Administrative Change Approval Form Order

East Port Water Reclamation Facility Expansion

Contract #:	2023000485	Change Order #:	3
Original Contract:	\$106,188,600.00	Original Contingency:	\$5,309,430.00
Previous Change Orders:	\$249,567.74	Previous Contingency Changes:	\$249,567.74
This Change:	(\$107,604.73)	New Contingency Balance:	\$5,059,862.26
Revised Contract Amount:	\$106,330,563.01	Original Contract Time:	900 days
Current Completion Date:	12/17/2026	Previous Additional Time:	159 days

CCU Change Order Request
East Port WRF Expansion - Poole and Kent
Change Order #3

PROPOSED CONTRACT MODIFICATION (PCM) No. 10

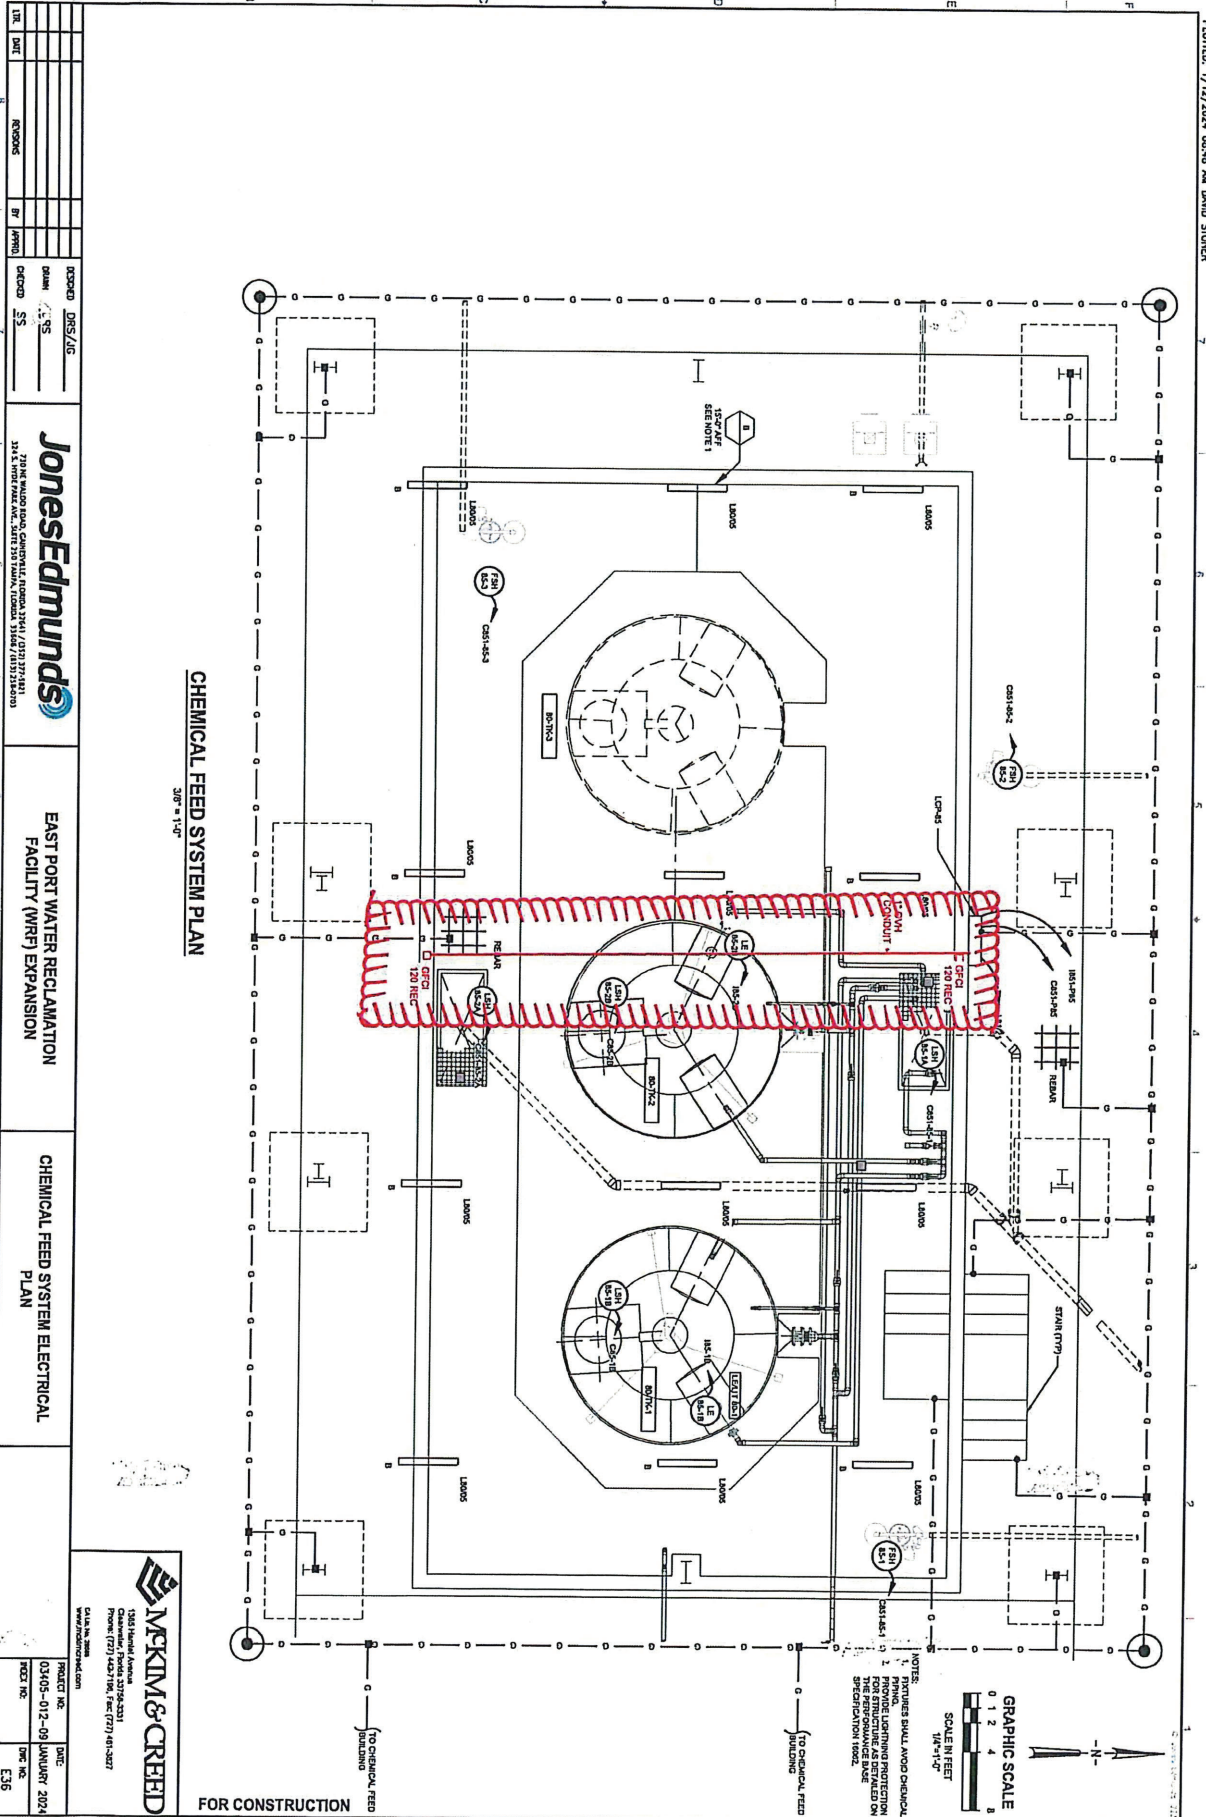
- Sump Pumps By Others*
1. Reconfigure 4-Inch Gravity drains from Sump area.
 - * 2. Furnish and Install (2) 120 VAC Sump Pumps, Conduit, Wiring and GFCI Receptacles.
 3. Provide Credit / Deduct for Omitted Drain Fittings, Valve, and Miscellaneous Appurtenances.

REASON FOR MODIFICATION: Eliminate potential for inadvertent CL2 disposal.

JonesEdmunds

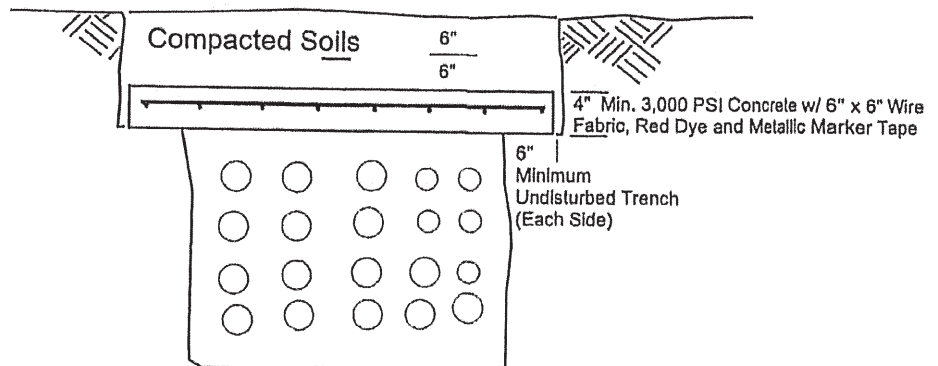
This change order request is based on the drawing by GS Fruecht dated 11-05-2024. Revised duct bank eliminating concrete encasement and replacing with a 4" Shock Pad.

PROPOSED CONTRACT MODIFICATION (PCM) No. 21

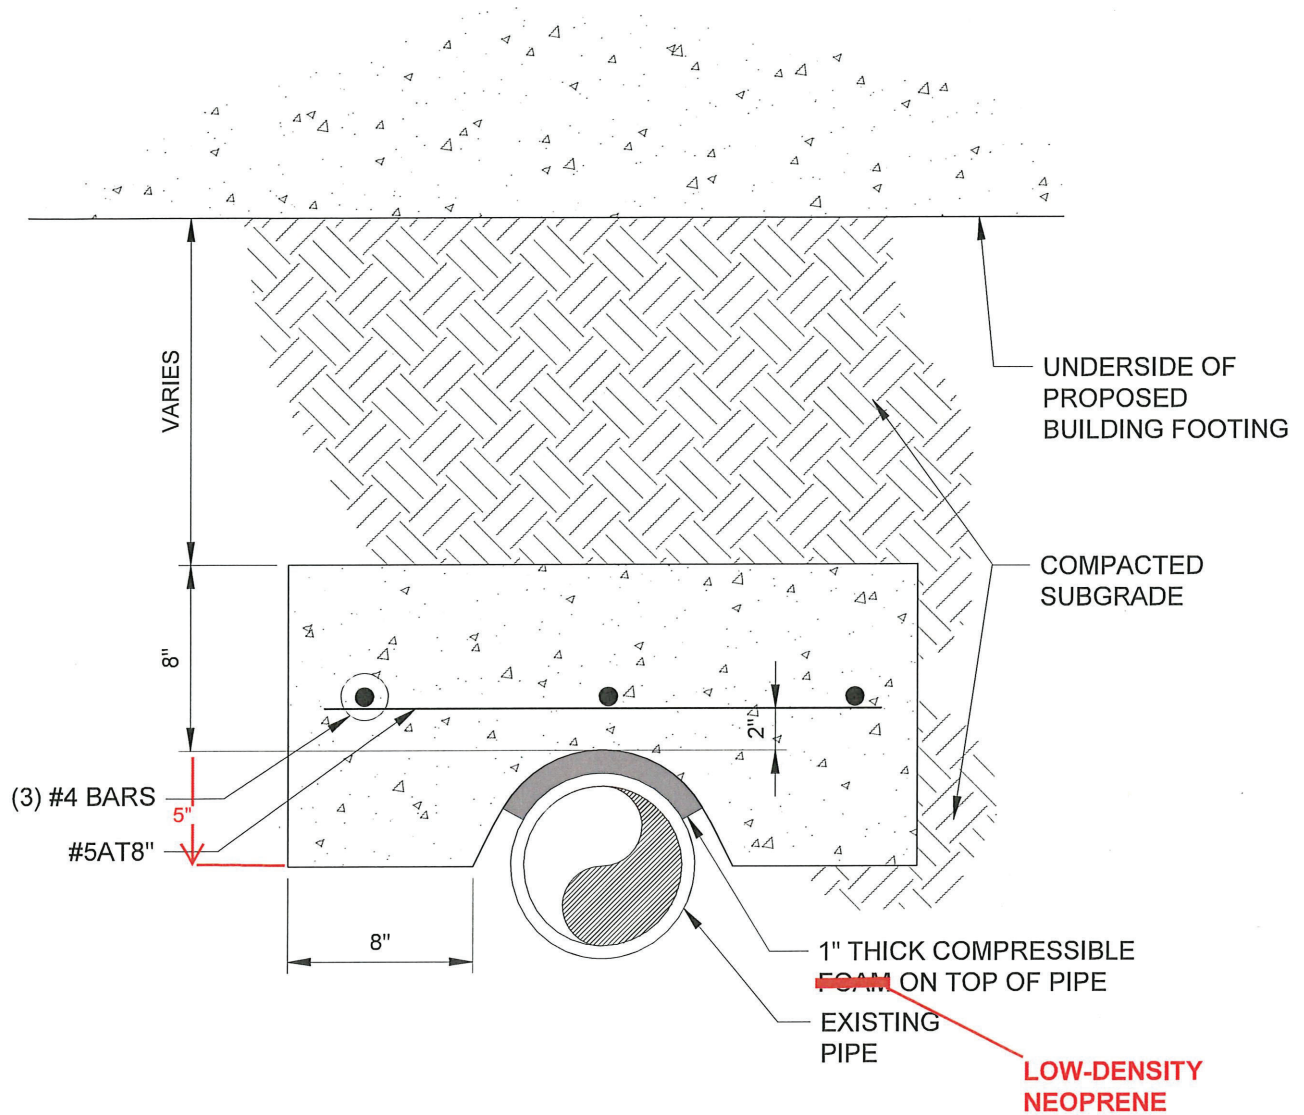
DESCRIPTION OF MODIFICATION: Please submit your proposal for an equitable adjustment in the contract amount and/or performance time in accordance with the following:
to furnish and install reinforced concrete shock pads at select areas over the existing 8" diameter piping. Please refer to details which identifies the profile, the extents, and the required low-density neoprene insulator.

REASON FOR MODIFICATION: Found existing pipe within footprint of new construction.
